### ADDENDUM NO. 2

**RE: Item #3, January 21, 2026 Letting - NH 0034(212)388, PCN 06PR, Lake County - Cold Milling, Asphalt Concrete Resurfacing, Pipe Work, Modify Intersection, Approach Slabs, Berm Repair, Lighting**

**PLANS:** Please destroy sheets 2, 3, 9, 123, 129, 139 & 145 and replace with the enclosed sheets, dated 1/9/26.

## PIPE CULVERT UNDERCUT

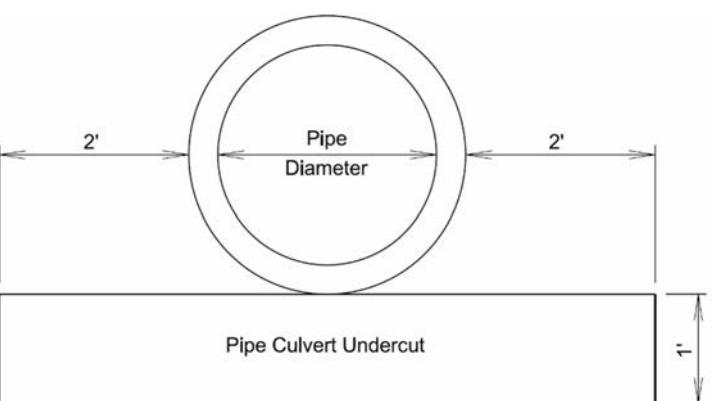
**Sheet 9:**

PIPE CULVERT UNDERCUT table was revised.

Station	Undercut Depth (Ft)	Pipe Culvert Undercut (CuYd)	Granular Material (Ton)
4+69	2	162	304
6+50	2	89	167
Total:		251	471

**(WEST BOUND LANES)  
APPROACH SLAB DETAILS (C)  
FOR**

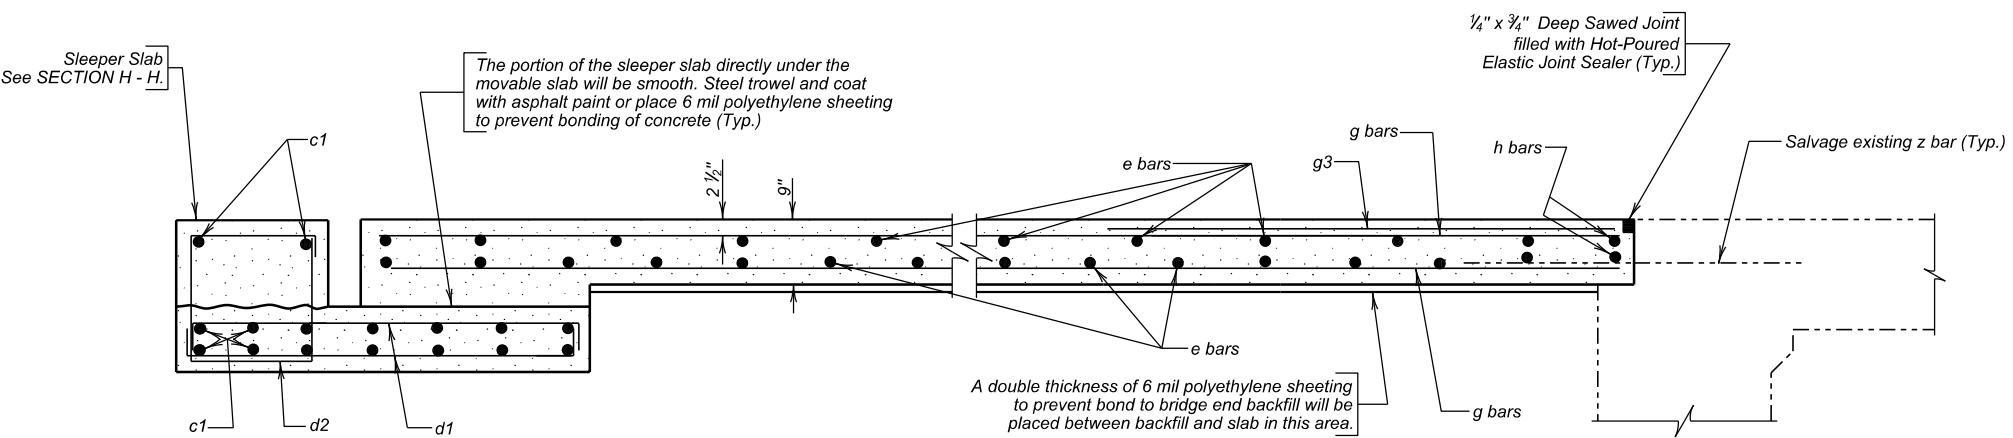
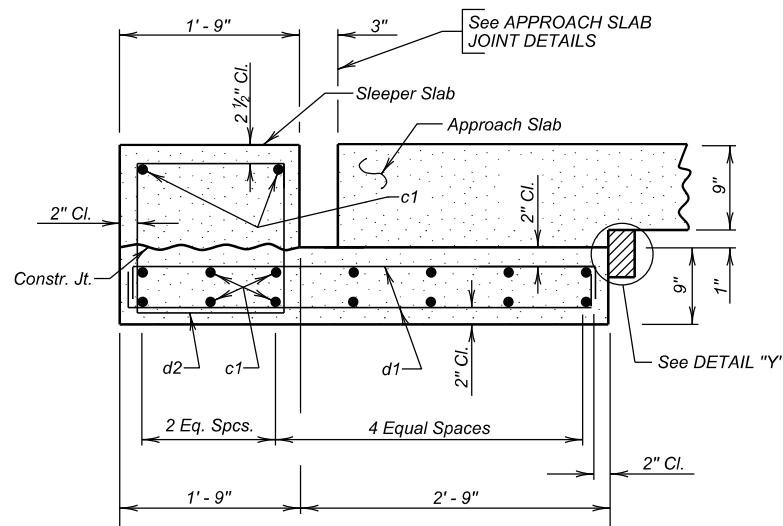
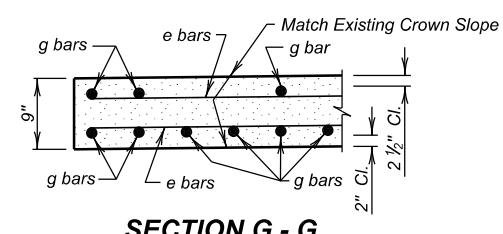
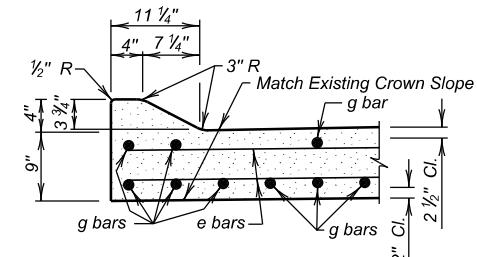
**Sheets 139 & 145:**

Remove Concrete Bridge Approach Slab quantity was revised.

<b>ESTIMATED QUANTITIES</b> (For Two Approach and Two Sleeper Slabs)		
<b>ITEM</b>	<b>UNIT</b>	<b>QUANTITY</b>
Remove Concrete Bridge Approach Slab	SqYd	390.6
Concrete Approach Slab for Bridge	SqYd	190.6
Concrete Approach Sleeper Slab for Bridge	SqYd	41.8
Base Course	Ton	28.7
